Appl. No. 10/628,191  
Amdt. Dated August 29, 2005  
Reply to Office Action of April 28, 2005

**Amendments to the Drawings:**

Fig. 4A

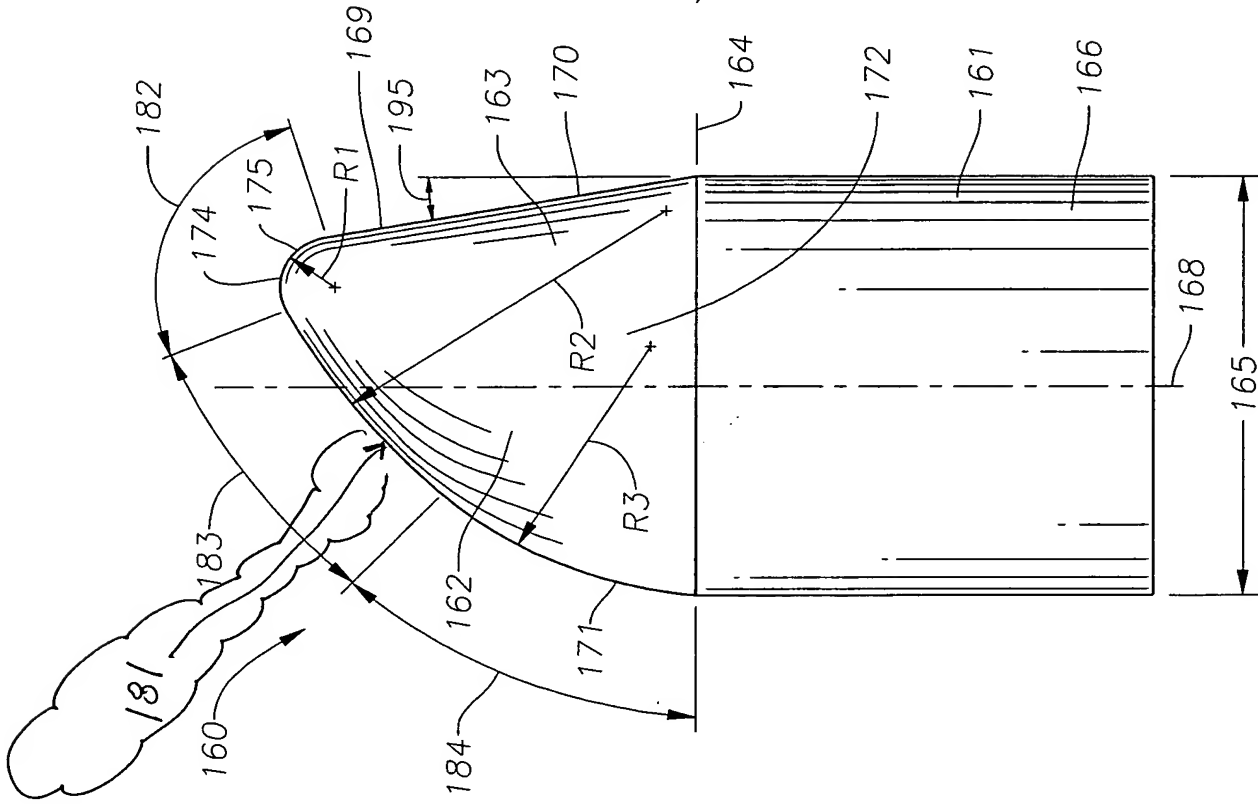
Replacement sheets of drawings 2 of 8, 3 of 8, 4 of 8, 6 of 8, and 8 of 8 are enclosed, reflecting amendments to drawing Figures 2, 3A, 4A, 5A, 6 and 7. These replacement sheets have been amended to include reference numerals 57a, 181 and 281, which the Examiner identified as included in the specification but missing from the drawings. No new matter has been added by these amendments. Likewise, the drawings have been amended to delete reference numerals 100 and 320 which the Examiner noted were not used in the specification. However, designations 193 and E have not been deleted from the drawings as they were included in the specification. Reference numeral 193 was described in paragraph 50, page 15 and identifier E was described in paragraph 56, page 17 of the original specification. For the Examiner's convenience, changes to these drawings are reflected on the additional set of attached replacement pages, with the changes shown in red ink.
